Change Notice

PCN No: 144

Product Type: AL126

PCN_124_AL126

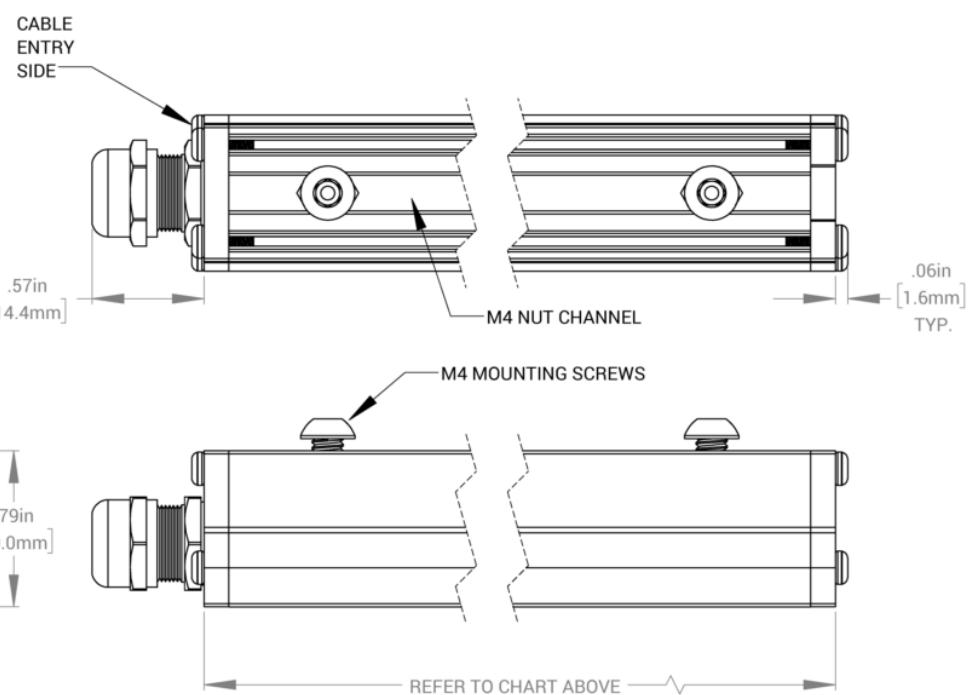
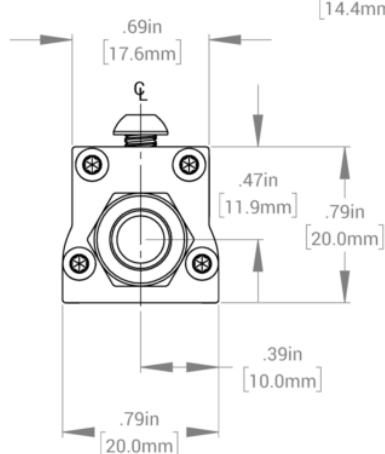
In an effort to improve our products, Advanced illumination (Ai) will update the LEDs used in the AL126 design. This change will result in a brighter, more uniform light at the same price*. Customers may still buy the current revision of this model until September 16th of 2016. After that time, orders for these products will be converted to their respective AL126 Revision A models.

This LED change will result in additional wavelengths being available: 365nm, 375nm, 385nm, 395nm, 405nm, 455nm, 530nm, 590nm, 730nm, 850nm and 940nm. Additionally the white LED color temperature will be changing from 6100K to 5000K.
